STATE OF MAINE
DEPARTMENT OF TRANSPORTATION
16 STATE HOUSE STATION
AUGUSTA, MAINE
04333-0016

November 18, 2008
Subject: **Bangor Hammond St Bridge**
Federal Project No. AC-IM-1264(300)X
State Pin No.012643.00
Amendment No. 1

STATE OF MAINE		DEPARTMENT OF TRANSPORTATION	
AC-IM-1264(300)X		BRIDGE NO. 5794	
PIN 12643.00		BRIDGE PLANS	
HAMDON STREET INTERSTATE 95		PENOBSCOT COUNTY	
BANGOR		ESTIMATED QUANTITIES AND GENERAL CONSTRUCTION NOTES	
SHEET NUMBER		2	
OF 59

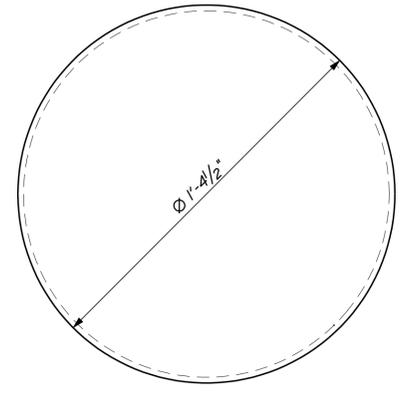
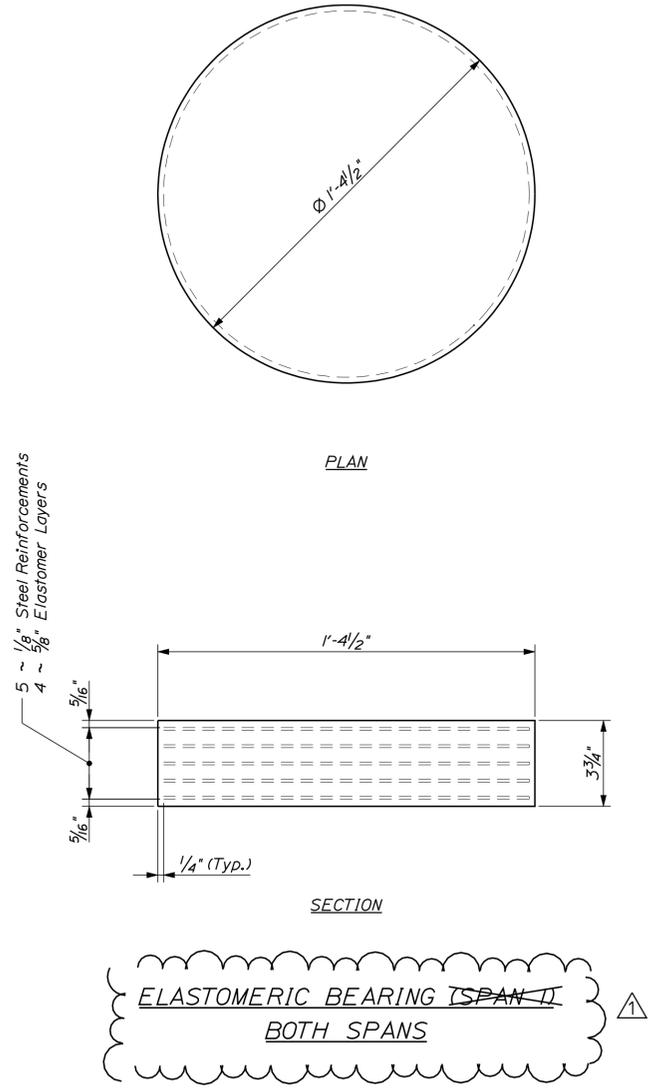
Question: Cofferdams or support of excavation is required for the structural excavation of the piers and abutments. Can a pay item be added for this scope of work?

Question: In the Plans, Sheet 2 of 59, Note 18. This note is confusing, are precast deck panels allowed?

Question: Will Item 403.209, 9.5mm HMA Incidentals be added for the 2” HMA sidewalks shown? Also, will Item 304.10, Agg. Subbase Gravel, be adjusted to include the sidewalks?

Response: This amendment changes the Estimate of Quantities on Sheet #2 and the Schedule of Items to include: 511.07 Cofferdam – Abutment No. 1, 1 Lump Sum; 511.07 Cofferdam – Pier, 1 Lump Sum; 511.07 Cofferdam – Abutment No. 2, 1 Lump Sum. The existing abutments and median pier must be removed in their entirety. The existing piers outside the interstate traveled way must be removed to a minimum of one foot below the bottom of the ditch and as required by any spatial conflicts with the proposed structure. Any bracing required for the removal of the existing outside piers is considered incidental to the related contract items.

Response: “Precast Concrete Deck Panels” as shown and defined in the Maine Department of Transportation Standard Details are not allowed. Any panels utilizing prestressing are not allowed. Refer to the Section 502 Special Provision for Reinforced Concrete Deck Panels which begins, “At the Contractor’s option, the Contractor may design precast concrete deck panels with mild reinforcement and submit the design and shop drawings for the Department’s review. Acceptance or rejection of any mild

Response: Yes. Pay Item 403.209 has been added to the contract, refer to the above changes. A few pavement item quantities have been adjusted to complete this correction. The quantity for Pay Item 304.10 is unchanged because the original quantity included the sidewalk.

HAMMOND STREET
INTERSTATE 95
PENOBSCOT COUNTY
BANGOR
PRECAST GIRDER NO. 1 & 8
LOCATION OF UTILITY INSERTS

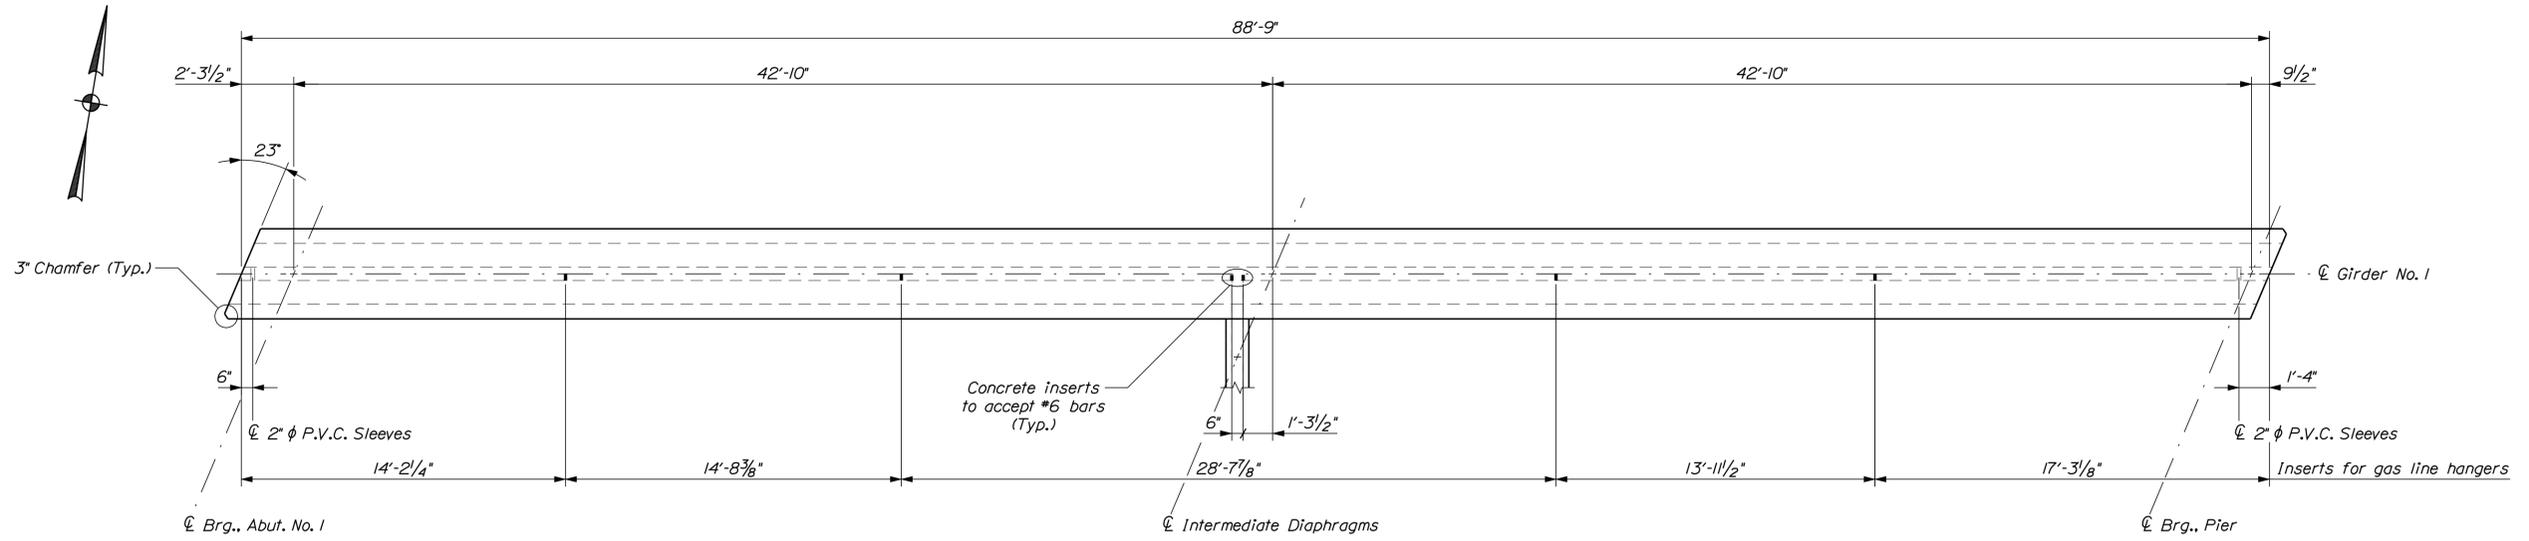
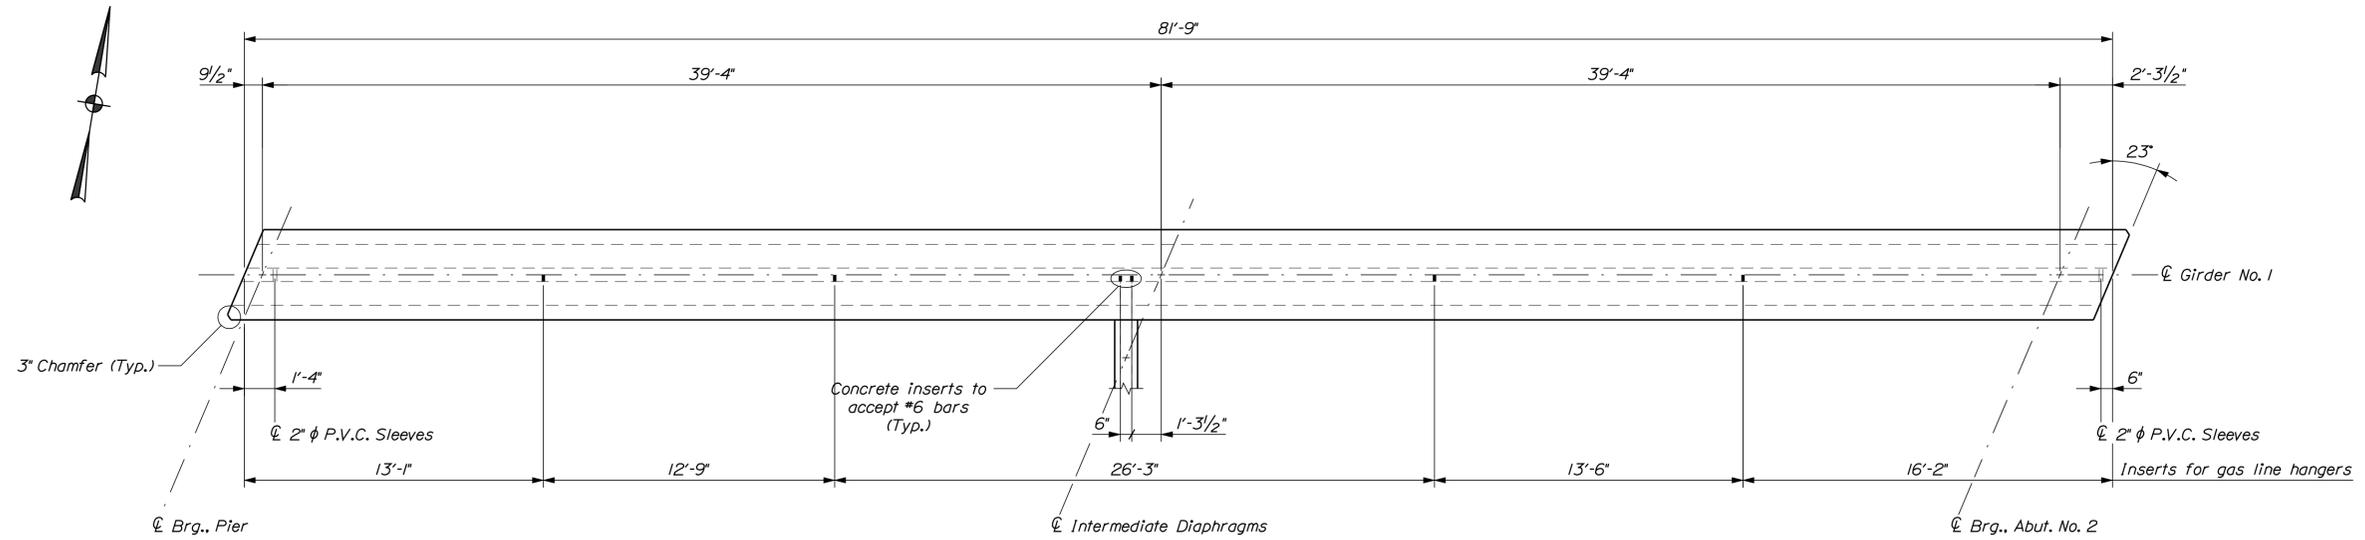
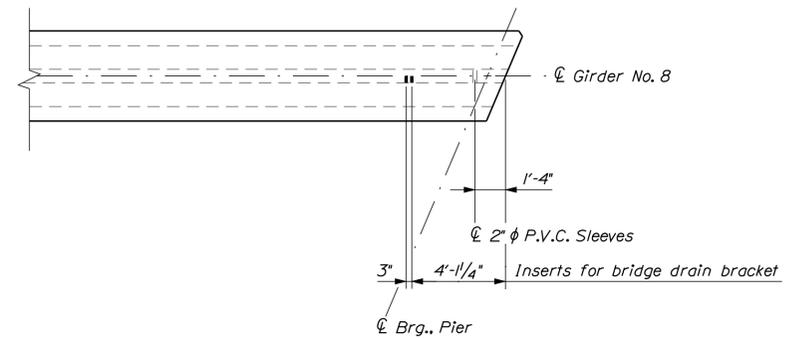
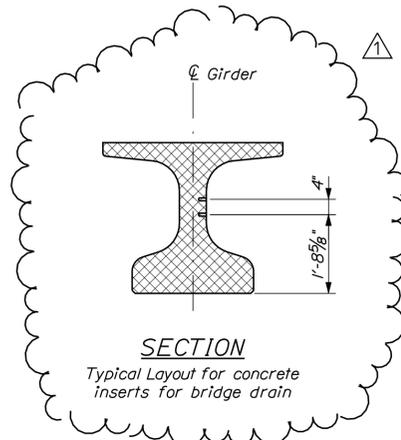
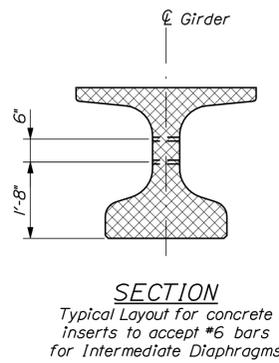
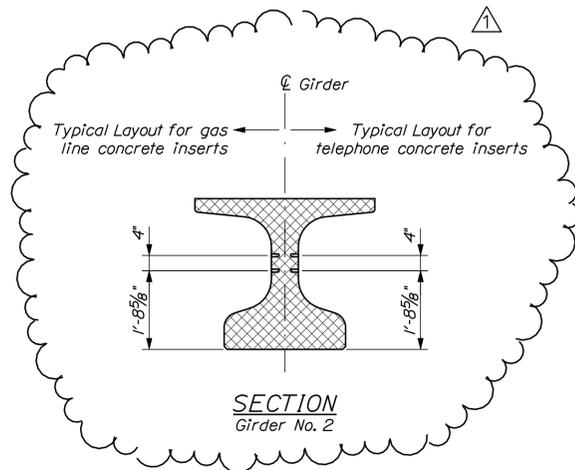
DESIGN DETAILED	D. ANDERSON	DATE	AUG 2008
CHECKED/REVIEWED	R. BULLGER	BY	D. SHAW
DESIGNS DETAILED		DESIGN REVIEWED	
REVISIONS 1 - D.E.S. Δ	LOCATION OF CONCRETE INSERTS REVISION	SIGNATURE	
REVISIONS 2		P.E. NUMBER	
REVISIONS 3		DATE	NOV 2008
FIELD CHANGES

HAMMOND STREET	PENOBSCOT COUNTY
INTERSTATE 95	
BANGOR	BRIDGE DRAINS

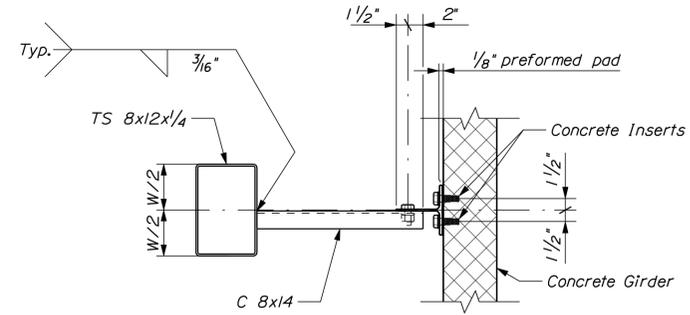
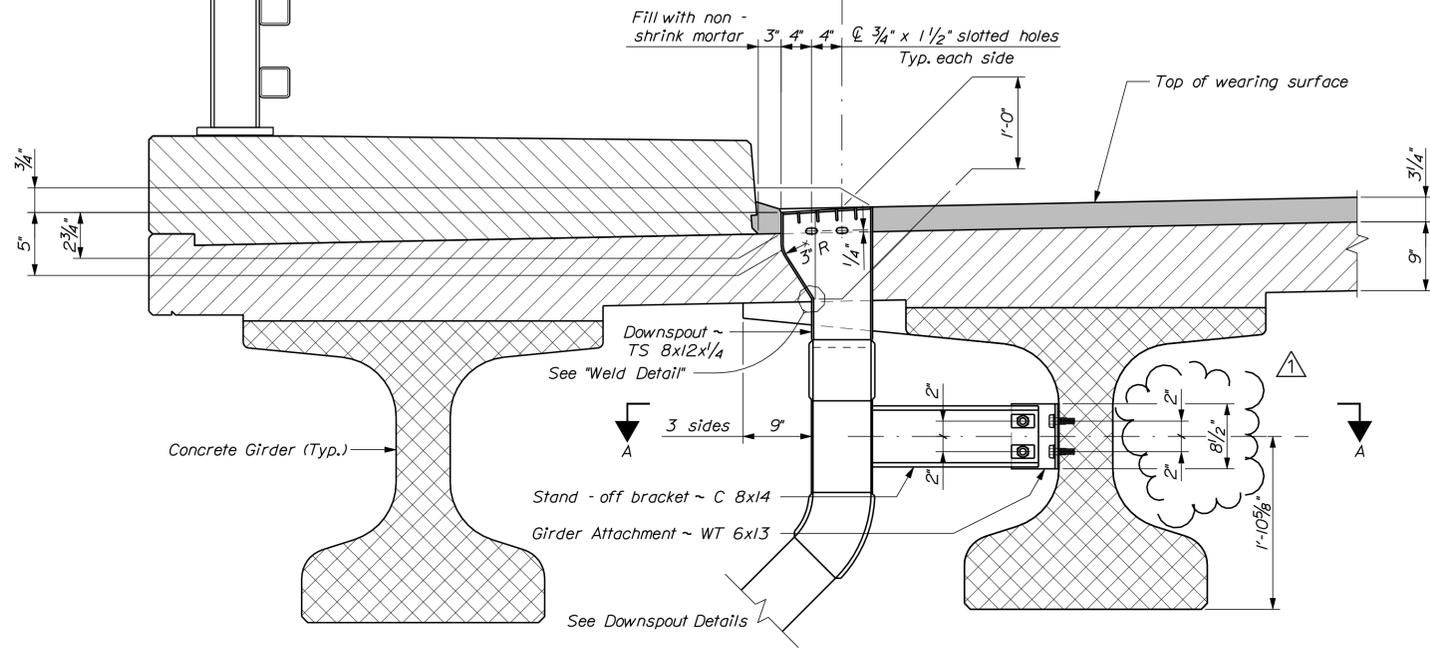
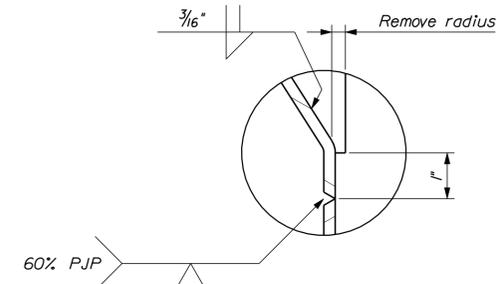
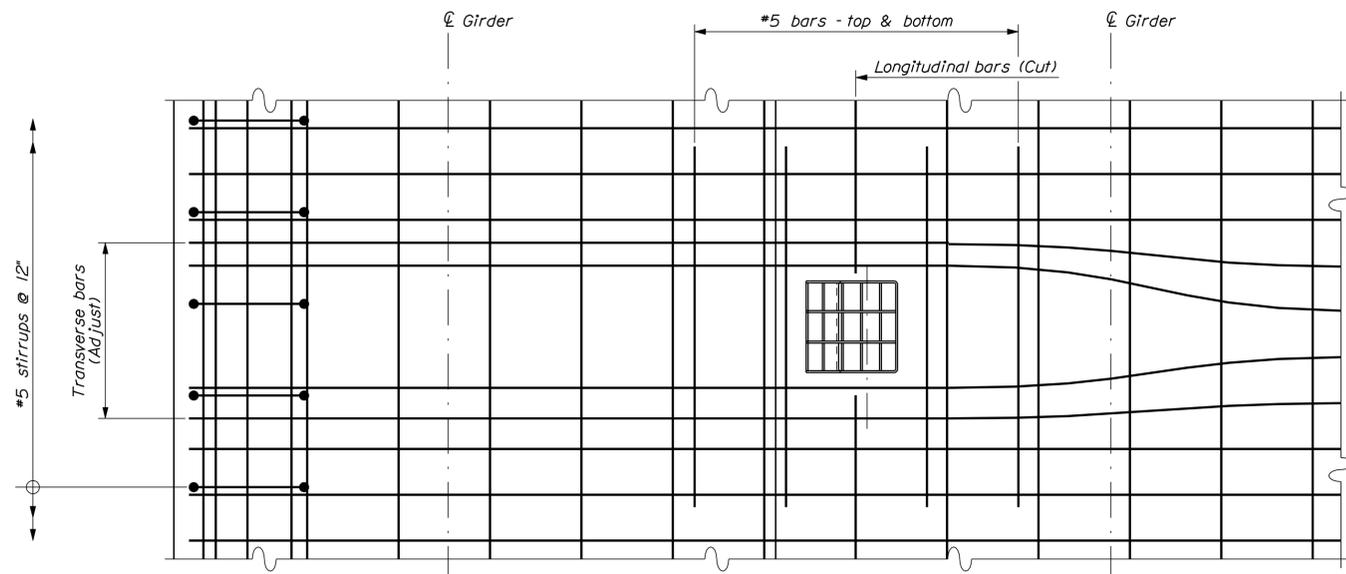
PROJ. MANAGER	BY	DATE	SIGNATURE	P.E. NUMBER	DATE
D. Anderson	D. SHAW	AUG 2008			
DESIGN-DETAILED	R. BULLGER				
CHECKED-REVIEWED					
DESIGN-DET FILED 02					
DESIGN-DET FILED 03					
REVISIONS 1 - D.E. SE	Bolt Layout Revised	Nov. 2008			
REVISIONS 2					
REVISIONS 3					
REVISIONS 4					
FIELD CHANGES
